Solicitation No.: B240003BAG

Solicitation Name: Sunniland / Nine Mile Run Drainage Improvement Project

Subject: Addendum Number 1

PLAN VIEW
N.T.S.

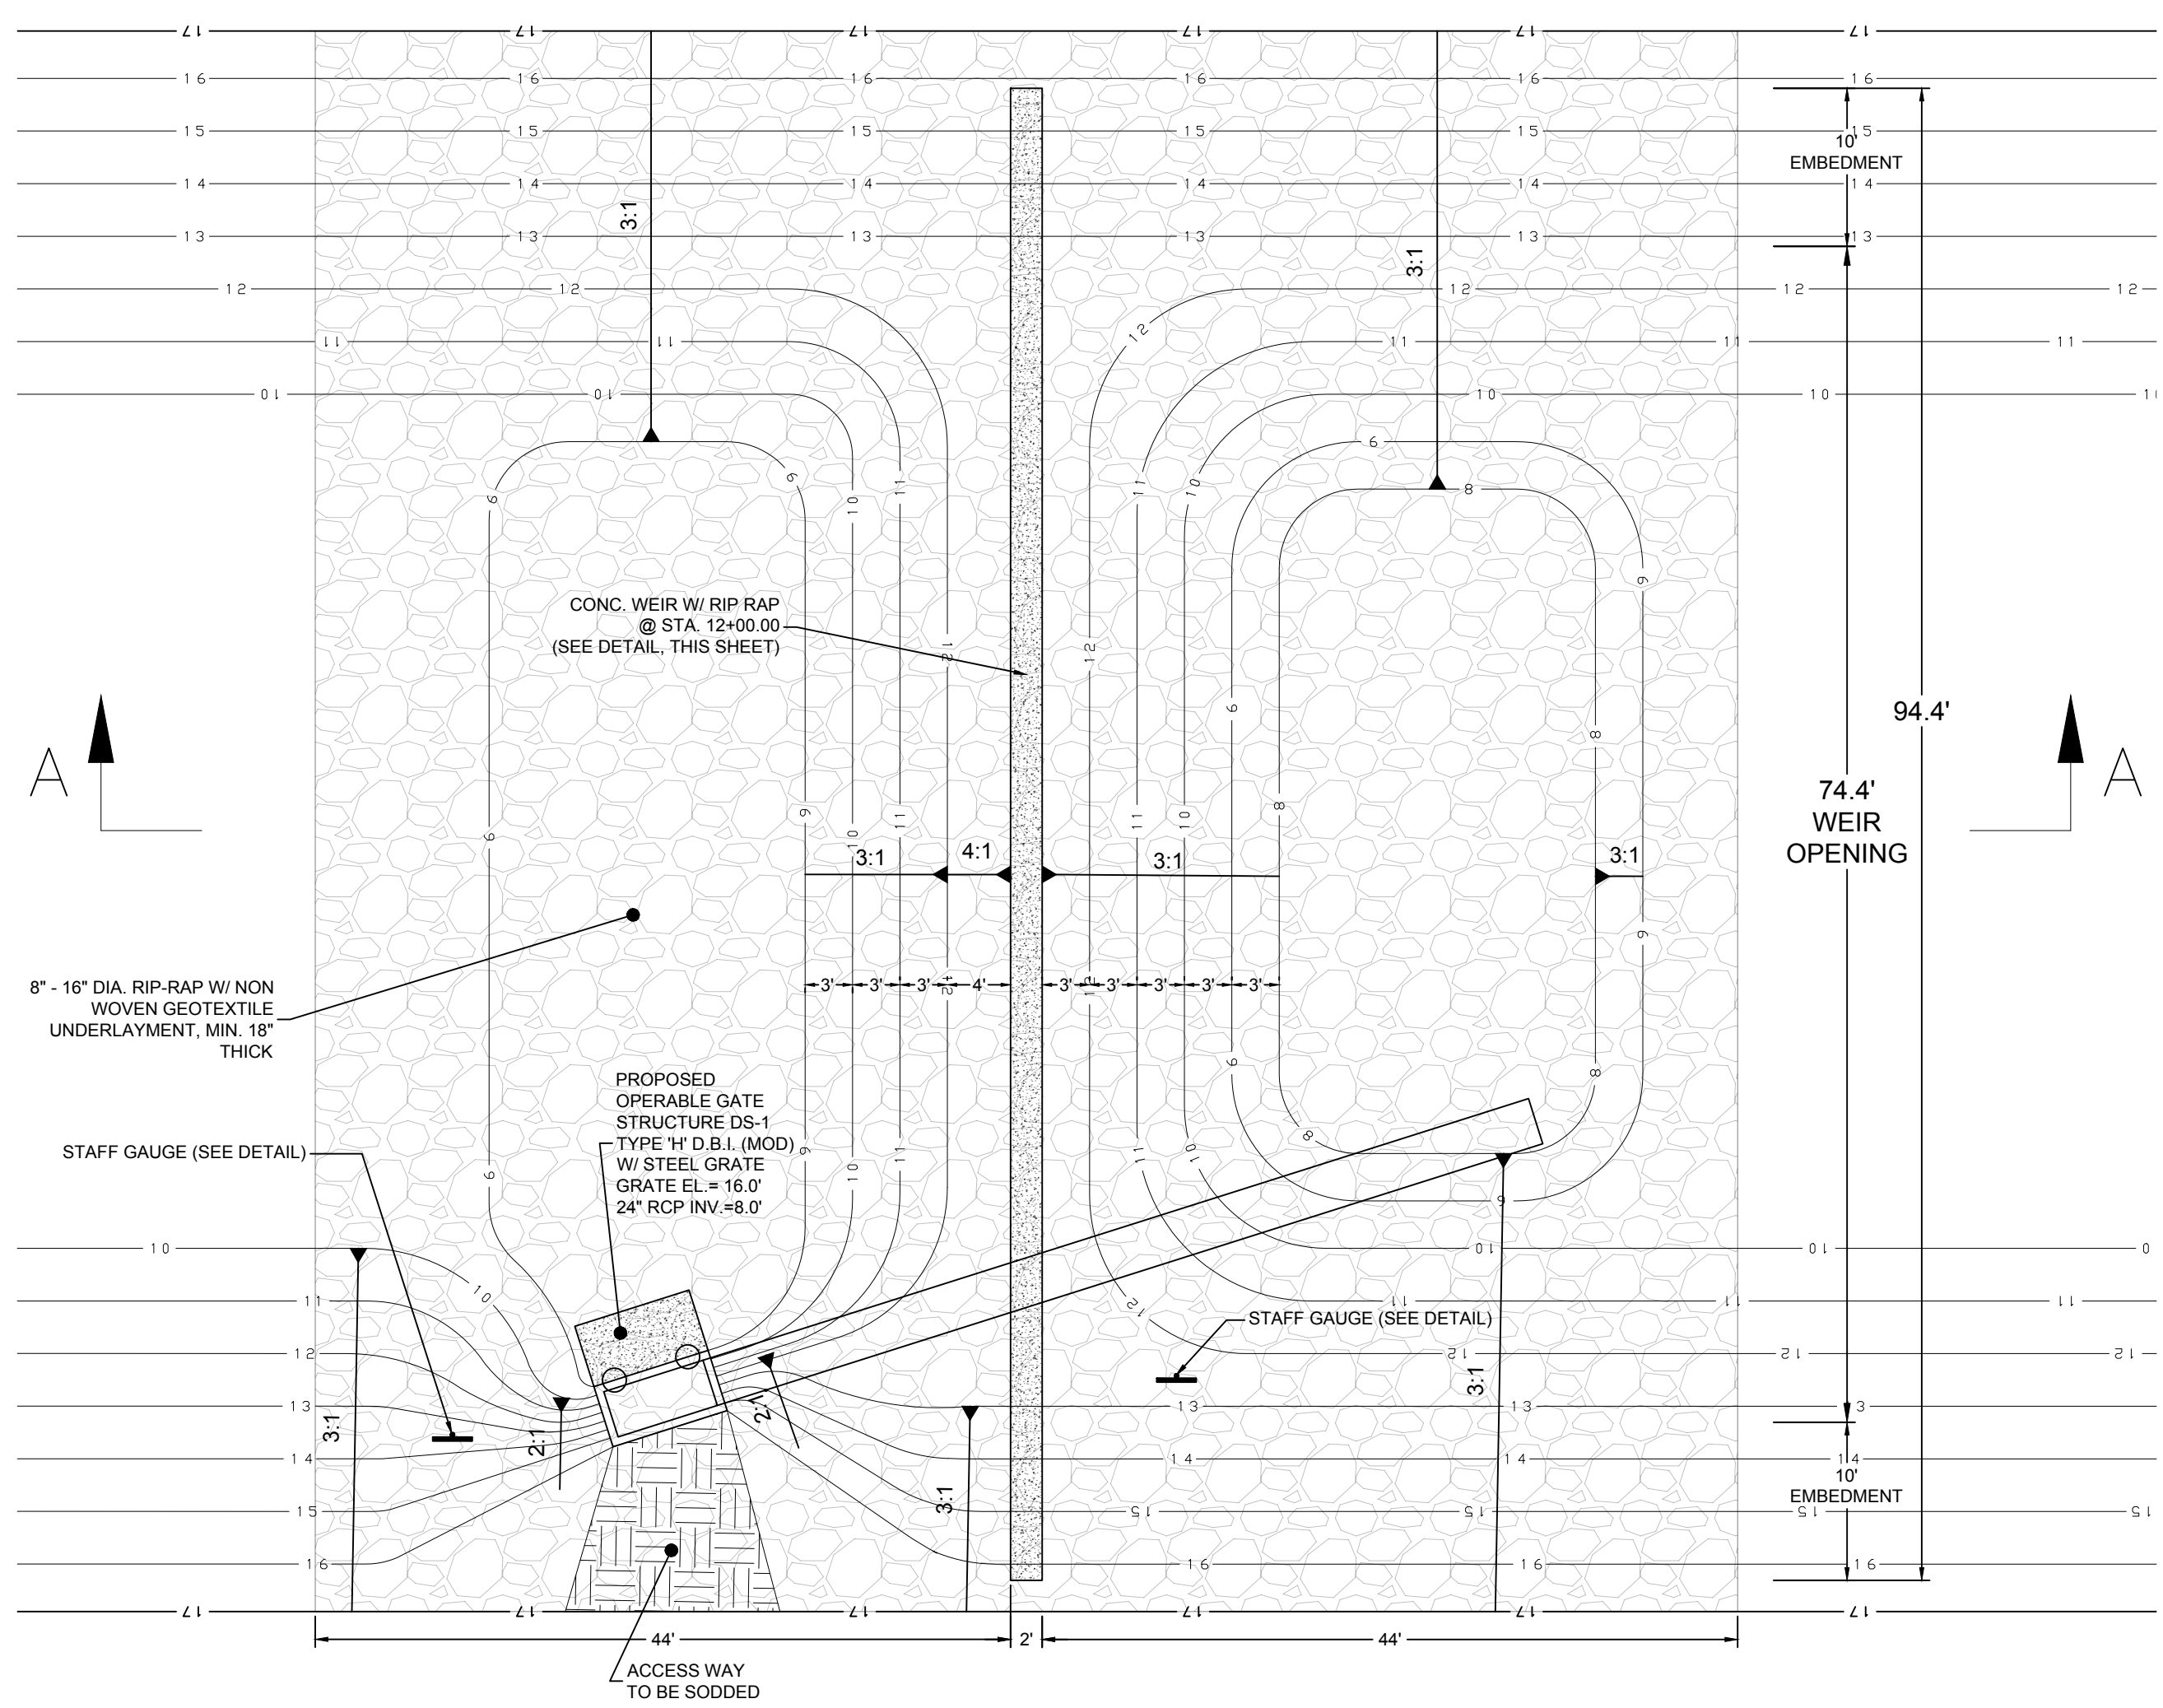
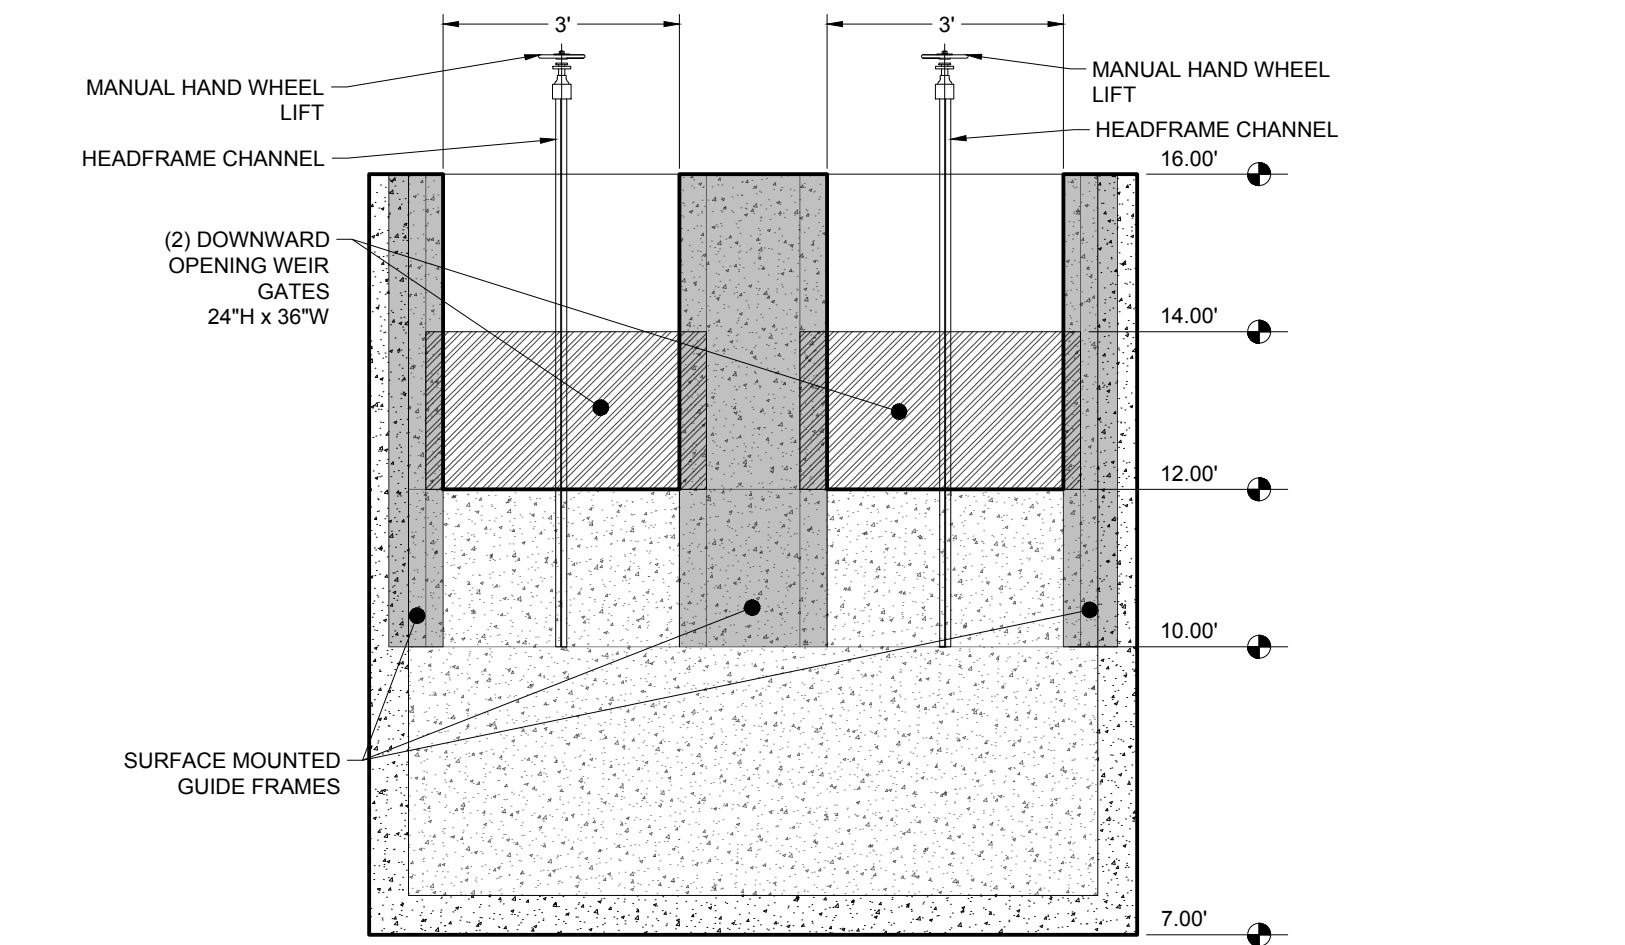
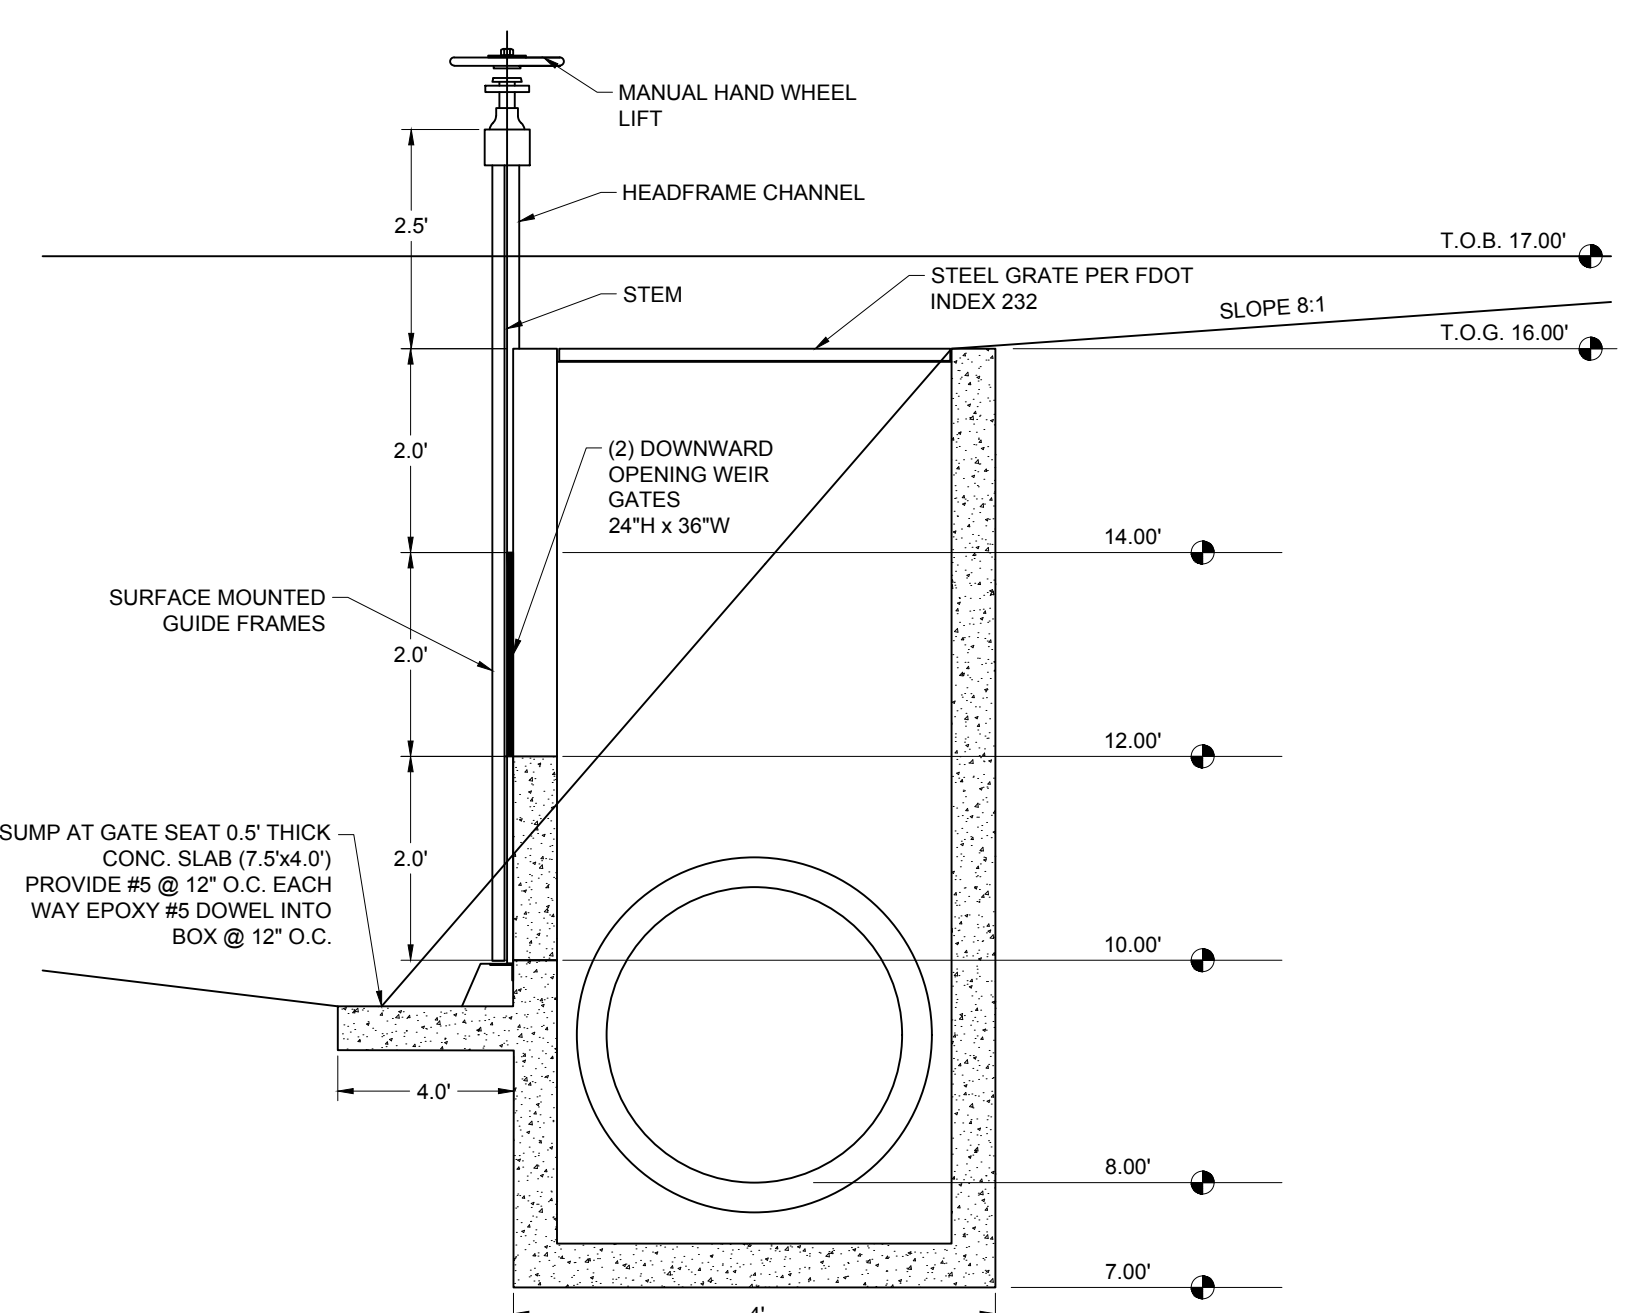
Answer	10-ft down from the top of bank
10.	Regarding weir's # 1 & 2, please clarify the following. Sheet 17 shows a FDOT index 252 that depicts a typical weir section. However, sheets 17A (weir # 1) & 17B (weir # 2) shows a typical weir section which is a concrete 2' x 2' area. Question, which section is correct?

15.	Can the engineer provide some additional clarification for the two through weirs? Sheet 17 depicts a typical section of a type of through weir, sheets 17A and 17B depict a 24" x 24" weir detail, however the X-section A-A shown on both sheets depicts a detail that does not reflect either of the individual weir details. Please advise.

Answer	Sheets 17A and 17B are correct. Disregard FDOT Index 252.
11.	If the work is to be majority if not all self-performed does the contractor still need to run an add for the DBE requirement?

Answer	Sheets 17A and 17B are correct. Ignore section on sheet 17.
16.	Drawing Sheet 5 depicts (3) thirty-inch RCP mitered end sections. However, the bid form does not list any. Can a new 30" MES bid item be included on a revised bid form?
